**JOINT REGIONAL PLANNING PANEL
(Sydney East Region)**

JRPP No:	2015SYE091
DA No:	DA15/0742
Local Government Area:	Sutherland Shire
Proposed Development:	Demolition of 14 dwellings and construction of 2 residential flat buildings containing 197 units and 3 levels of basement carparking
Street Address:	660-664 Kingsway and 2-22 University Road, Miranda Lots 27 – 40 in DP 7580 (14 lots total)
Applicant/Owner:	Galileo Miranda Nominee Pty Limited
Number of Submissions:	Two (2)
Regional Development Criteria (Schedule 4A of the Act)	General Development over \$20 million
List of All Relevant s79C(1)(a) Matters	<ul style="list-style-type: none"> • State Environmental Planning Policy (State and Regional Development) 2011 • State Environmental Planning Policy (Infrastructure) 2007 • State Environmental Planning Policy No. 65 (Design Quality of Residential Apartment Development) • Greater Metropolitan Regional Environmental Plan No. 2 – Georges River Catchment • Sutherland Shire Local Environmental Plan 2015 • Draft Sutherland Shire Development Control Plan 2015 • Apartment Design Guide • Section 94 Contributions Plans

Assessment Report and Recommendation Cover Sheet

Image 1 – Minimum 19m building setback as highlighted yellow (red indicates non-compliant portions of the proposal)

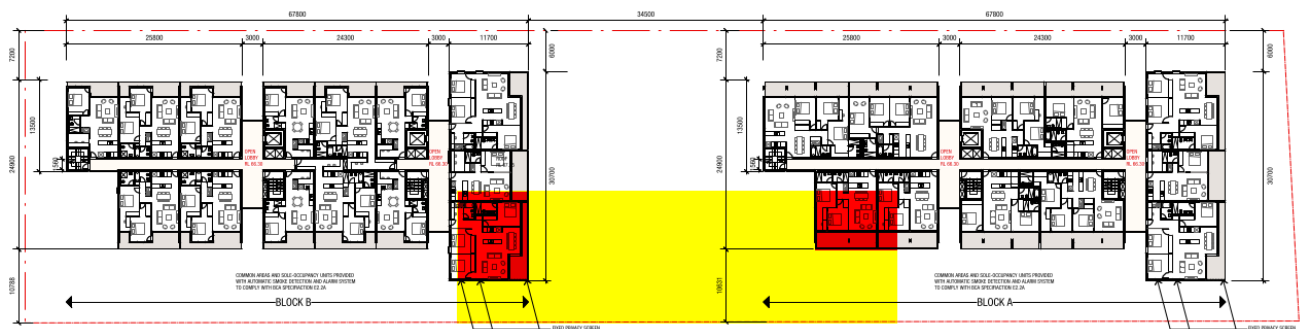
The proposal fails to comply with the minimum building setback of 19m from the eastern boundary, generally adjacent to the Sensory Playground of Miranda Public School, as required by DSSDCP 2015. This particular development control was the outcome of meetings held prior to DA lodgement between the developer, the Department of Education, Miranda Public School and Council.

Refer to Image 1 below. The minimum 19m setback is depicted by yellow shading. The proposal involves 2 incursions into the 19m building setback, which are depicted by red shading. These non-compliant sections are 6m and 10.63m from the boundary and they equate to 35% of the 19m setback area's width. Therefore, 65% of the 19m setback area will have no built form.

SSDCP 2015 requires that the remainder of the site (*i.e.* outside the highlighted yellow section) have a 9m setback from the eastern side boundary. Two north facing apartments have a 11.7m long eastern wall that is set back 6m – the southernmost of these apartments has only a very small section of wall outside the highlighted yellow 19m setback area. This outcome is considered to be acceptable on the basis that all east facing balconies are setback 10.63 – 10.79m, *i.e.* 1.63 – 1.79m greater than the 9m setback required. This increased setback satisfactorily offsets the non-compliant sections.

This outcome is supported by the NSW Department of Education and the Principal of Miranda Public School. It is preferred to 3 compliant buildings as the central communal open space area provides relief between built forms. A letter of support co-signed by the NSW Department of Education Manager Sydney Asset Management Unit and the Principal of Miranda Public School is held at **Appendix B**.
